### Report informal working group membrane tanks

Transmitted by the governments of France and the Netherlands\*, \*\*

### Provisional amendments to the ADN 2019

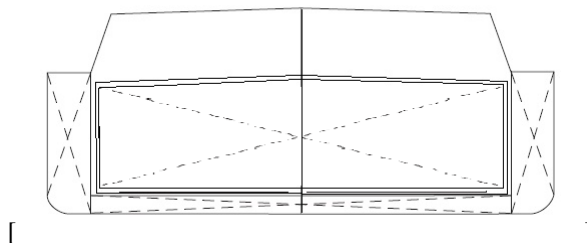
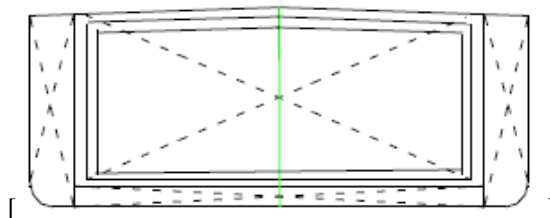
**(d) Membrane tank means a cargo tank which consists of a thin liquidtight and gastight layer (membrane) and insulation supported by the adjacent inner hull and inner bottom structure of a double hull vessel.**”
